Interactive comment on “Bayesian networks modelling in support to cross cutting analysis of water supply and sanitation in developing countries” by C. Dondeynaz et al.

C. Dondeynaz et al.

Received and published: 5 July 2013

Fig. 1.

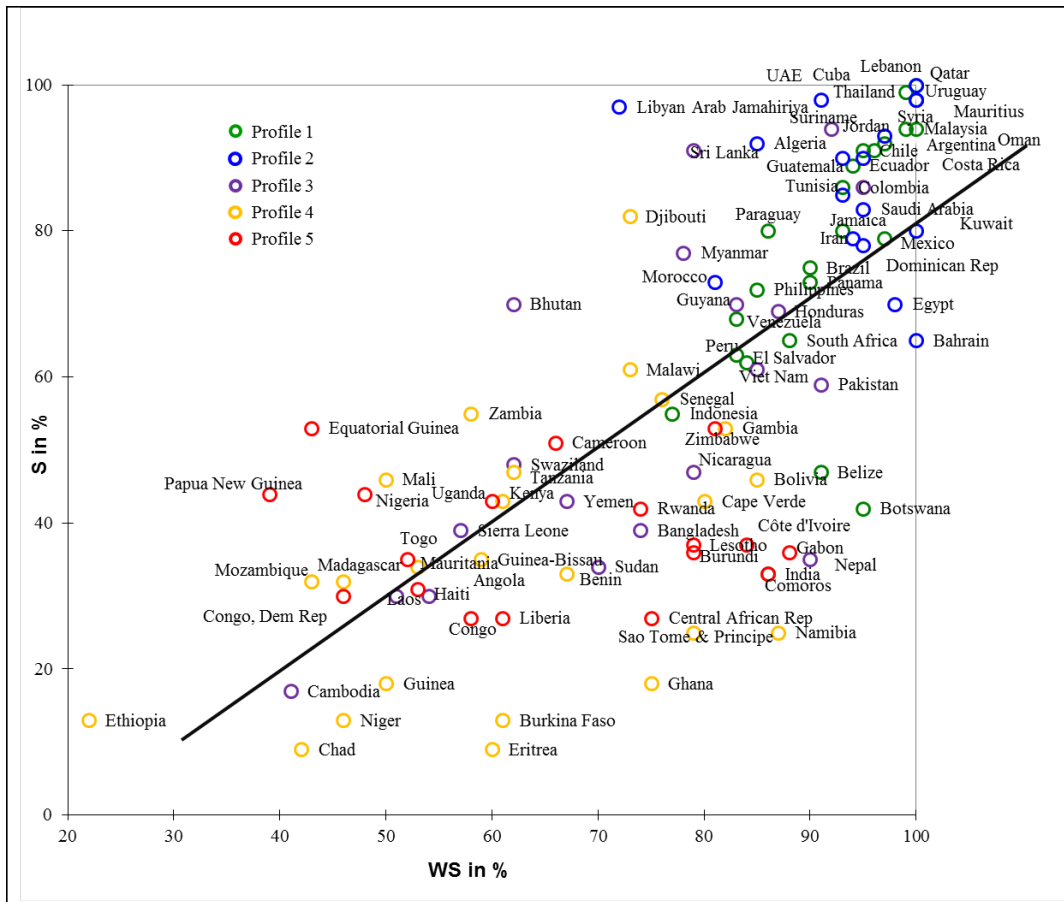
SPECIFIC COMMENTS Fig. 7 is not clear and should be improved.

It has been modified and enclosed to this comment.
